INDIAN POINT UNIT 2  
CONTAINMENT INSERVICE INSPECTION  
FIRST PERIOD EXAMINATIONS

Category E-A, Liner General Visual Examination  
Tab E - Inspector Certification Records

GENERAL VISUAL EXAMINATION OF CONTAINMENT LINER  
FOR ASME SUBSECTION IWE

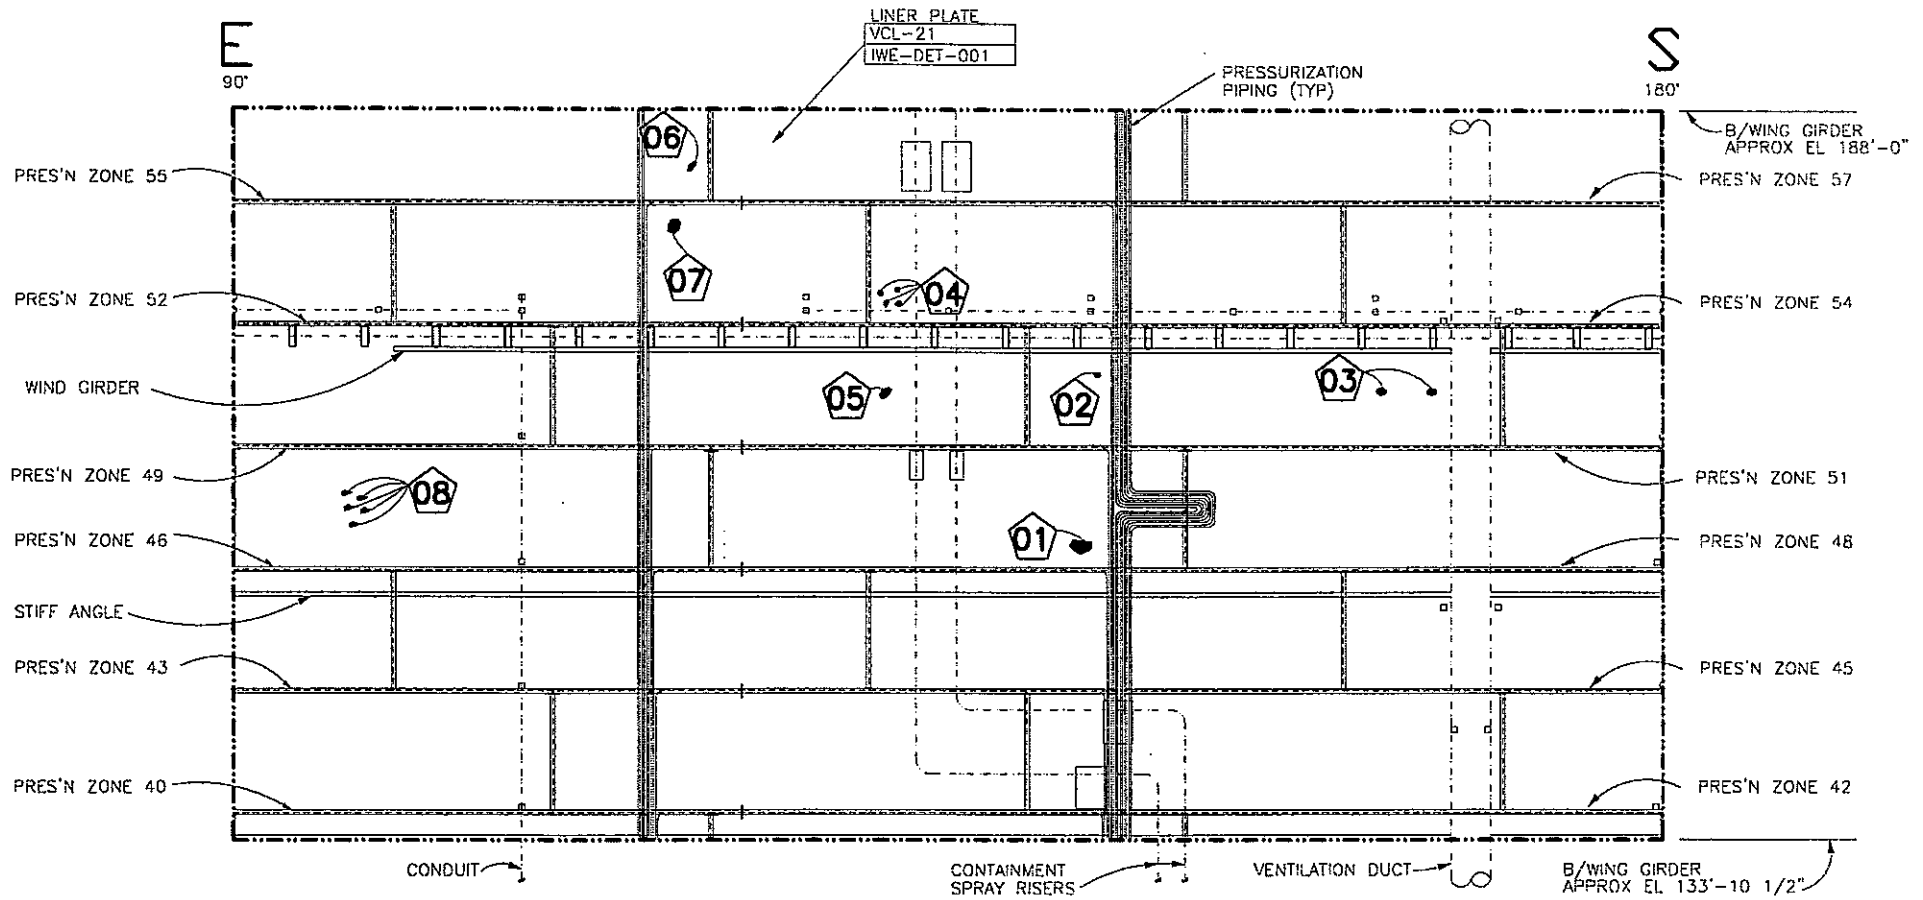
Item No.	Description	Photo
01	One (1) 5"x 5" area showing top coating peeling and delamination and checking. Primer intact. Checking to ASTM D660, Mosaic, Grade 8.	None
02	One (1) 2" x 2" area showing lubricant product residue. Top coat intact.	00030914.jpg
03	Two (2) coated areas from prior scaffold welding show signs of rusting to ASTM D610, Grade 5, 3% of surface area. Primer intact.	None
04	Four (4) 2"x 2" areas showing top coating peeling and delamination and checking. Primer intact. Checking to ASTM D660, Mosaic, Grade 8.	None
05	One (1) 3"x 3" area showing top coating delamination and checking. Primer intact. Checking to ASTM D660, Mosaic, Grade 8.	None

Item No.	Description	Photo
06	One (1) 2"x 2" area showing top coating peeling and delamination and checking. Primer intact. Checking to ASTM D660, Mosaic, Grade 8.	None
07	One (1) 5"x 5" areas showing top coating peeling and checking. Primer intact. Checking to ASTM D660, Mosaic, Grade 8.	00030915.jpg
08	Five (5) 1"x 1" areas showing top coating delamination checking. Primer intact. Checking to ASTM D660, Mosaic, Grade 8.	None

Item No.	Discussion	Acceptable	Additional Eval. Req'd.
01, 04 - 08	The reported conditions reflect deterioration of the coating (loss of bond between the primer and topcoat). Since the primer is intact there is no reason to suspect any degradation of the liner. This condition is not significant relative to Containment structural integrity. Examination at the next regular inspection period is sufficient to monitor these conditions.	✓	
02	The reported condition is debris on the surface of the liner and does not reflect degradation.	✓	
03	The welds appear to be remnants from previous attachments, most likely scaffolding brackets used during construction. The weld surface is irregular and thus the coating will not bond well. The corrosion is minor and does not reflect any significant loss of liner material. Examination at the next regular inspection period is sufficient to monitor this condition.	✓

**LINER INSPECTION ZONE IWE-DOME-002**

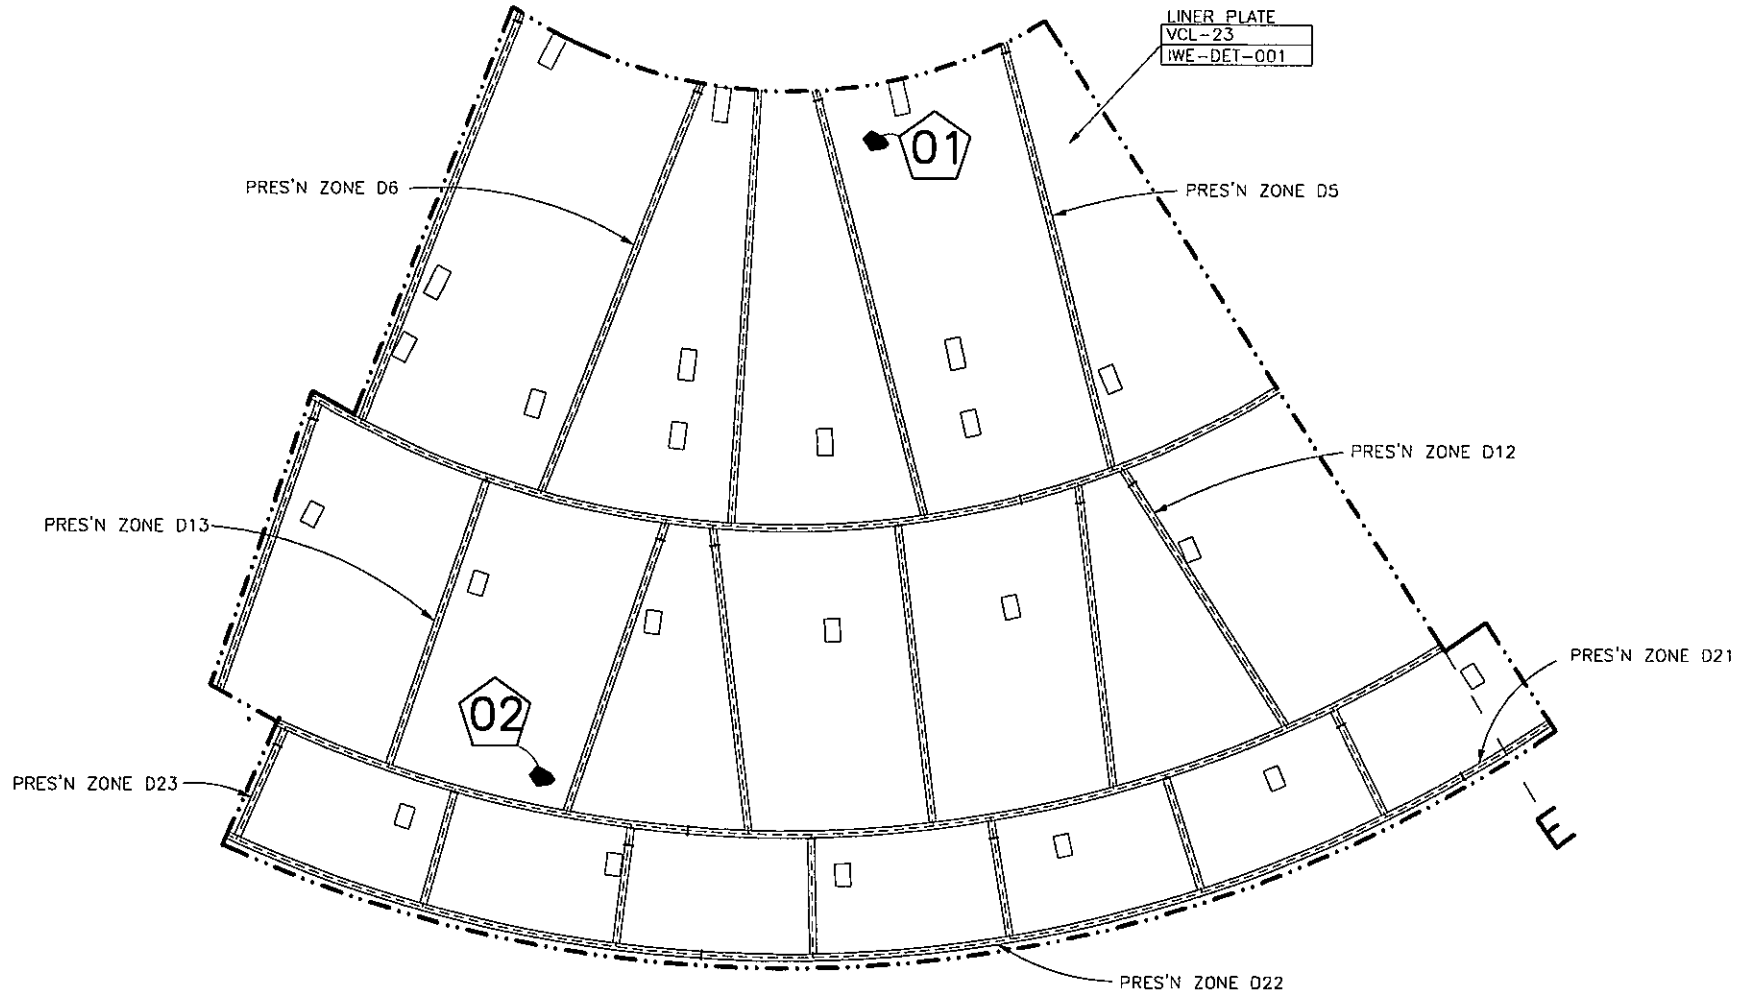
Item No.	Description	Photo
01	One (1) area approximately 4"x 4" located in the 4th top course from the left shows delamination and peeling in topcoat. Primer intact.	None
02	One (1) area approximately 4"x 5" located in the 2nd course from the left in the middle courses shows delamination and peeling in topcoat. Checking around removed area. Primer intact. Checking classified as ASTM D660, Mosaic Grade 8.	None

Item No.	Discussion	Acceptable	Additional Eval. Req'd.
01, 02	The reported conditions reflect deterioration of the coating (loss of bond between the primer and topcoat). Since the primer is intact there is no reason to suspect any degradation of the liner. This condition is not significant relative to Containment structural integrity. Examination at the next regular inspection period is sufficient to monitor these conditions.	✓

**LINER INSPECTION ZONE IWE-DOME-003**

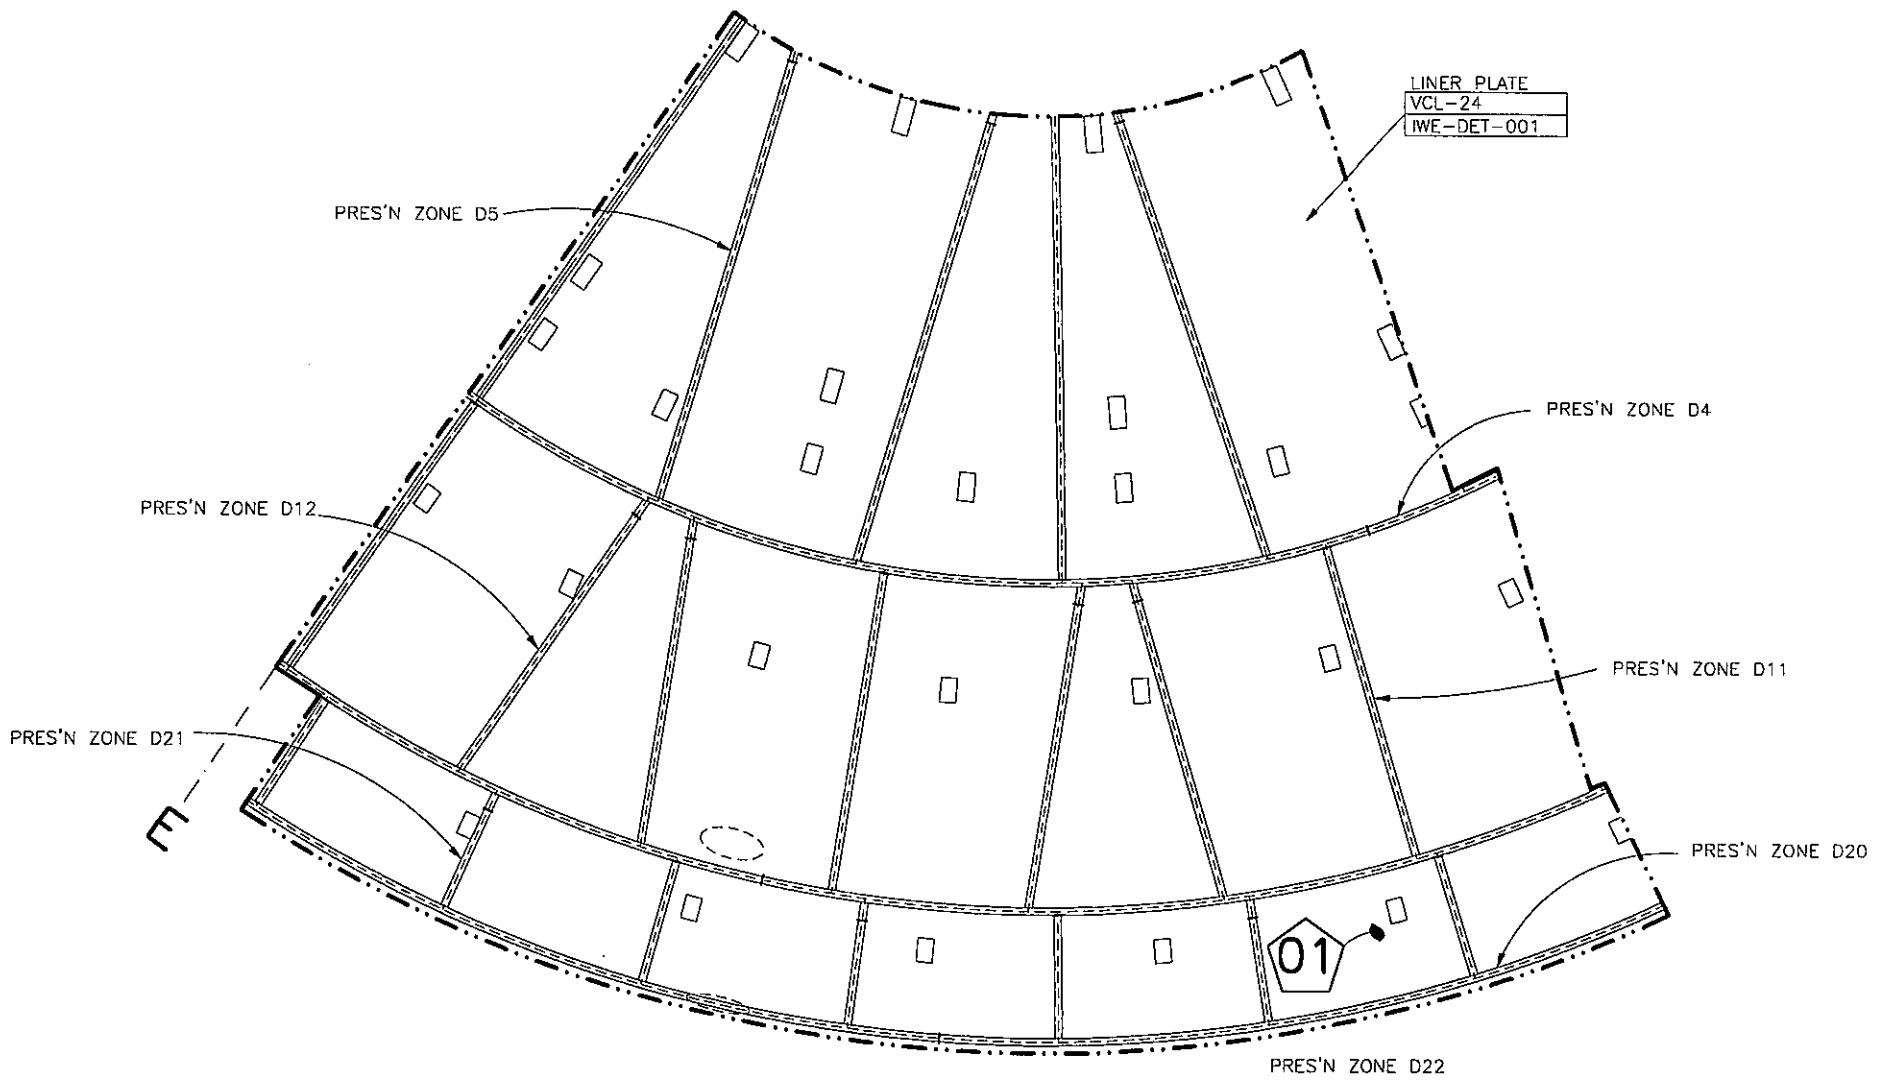
Item No.	Description	Photo
01	Five (5) areas approximately 2-sq. in. located in the 2nd course from the right in the lower courses shows delamination and peeling in topcoat. Checking around removed area. Primer intact. Checking classified as ASTM D660, Mosaic Grade 8.	None

Item No.	Discussion	Acceptable	Additional Eval. Req'd.
01	The reported conditions reflect deterioration of the coating (loss of bond between the primer and topcoat). Since the primer is intact there is no reason to suspect any degradation of the liner. This condition is not significant relative to Containment structural integrity. Examination at the next regular inspection period is sufficient to monitor these conditions.	✓

**LINER INSPECTION ZONE IWE-DOME-007**

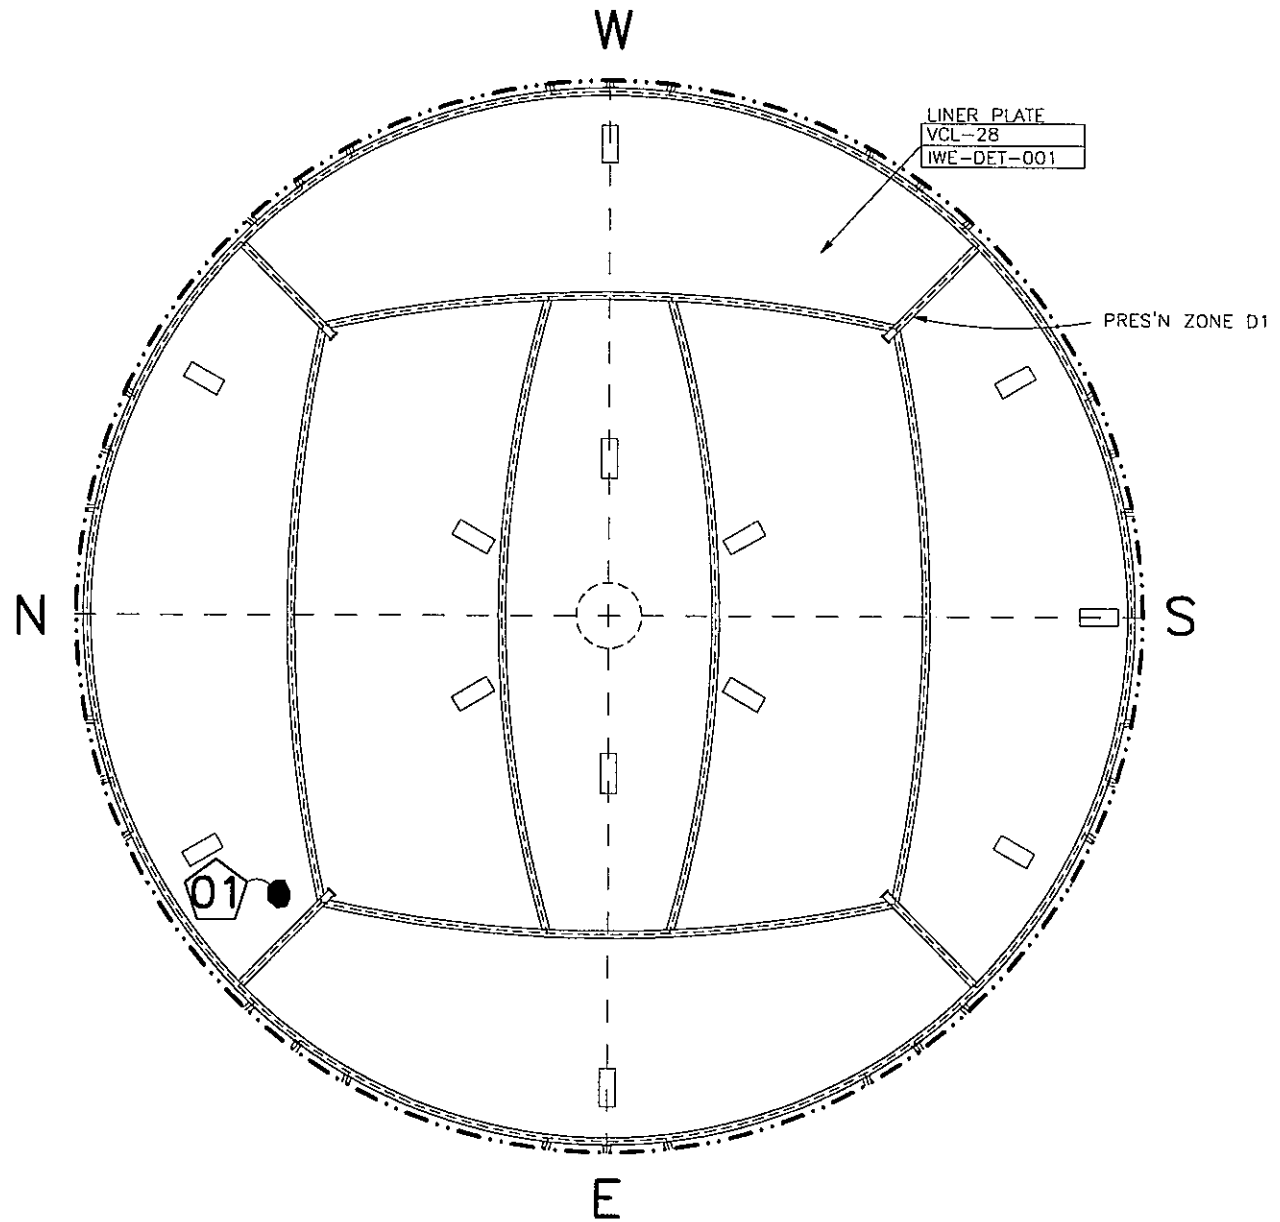
Item No.	Description	Photo
01	One (1) area approximately 2-sq. ft. located in the left outside course shows delamination and peeling in topcoat. Checking around removed area. Primer intact. Checking classified as ASTM D660, Mosaic Grade 8.	None

Item No.	Discussion	Acceptable	Additional Eval. Req'd.
01	The reported condition reflects deterioration of the coating (loss of bond between the primer and topcoat). Since the primer is intact there is no reason to suspect any degradation of the liner. This condition is not significant relative to Containment structural integrity. Examination at the next regular inspection period is sufficient to monitor this condition.	✓
